CONSULTANT ADVICE NOTICE

PROJECT: 11 BEACH STREET FRANKSTON

CAN NO: X-004[2.0]

STRUCTURAL/CIVIL – ‘FLOOD LEVEL’ AND ‘BUILD OVER EASEMENT’ STATEMENT

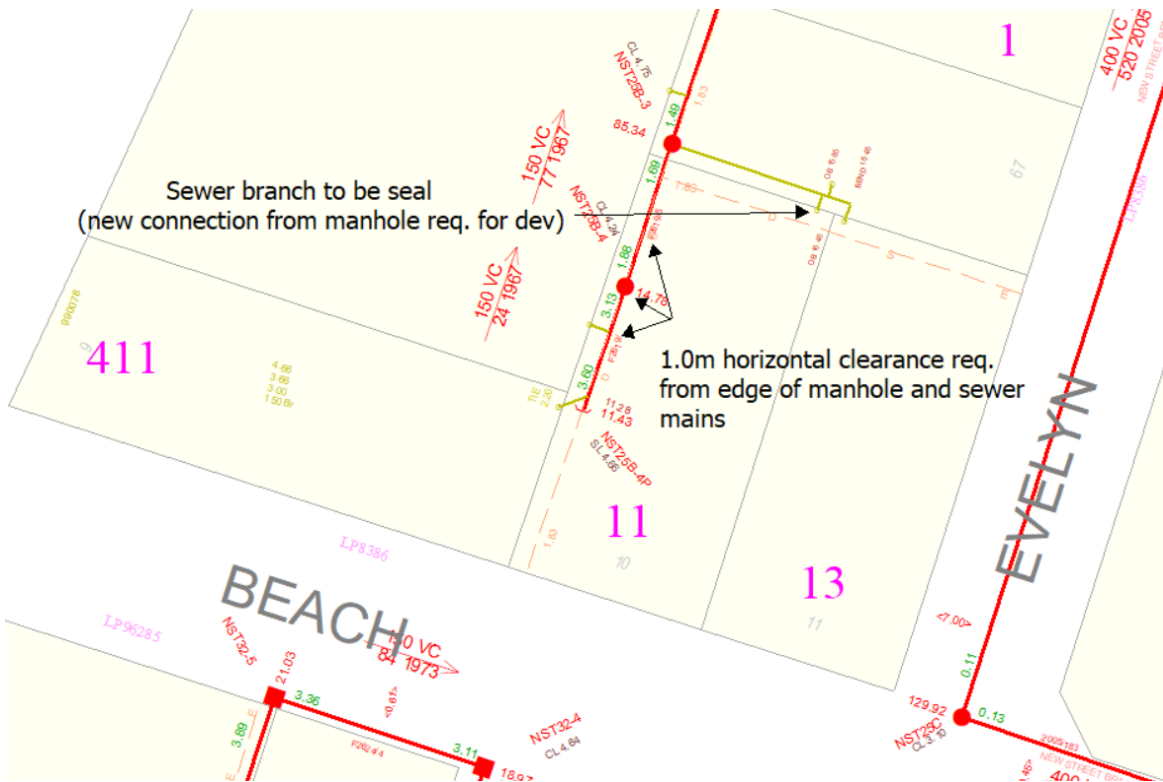
In terms of the rear easement, I can confirm that South East Water does not have any sewer mains but does have the existing sewer branch but this will be cut and sealed and a new connection from a manhole in your designed location. See below.
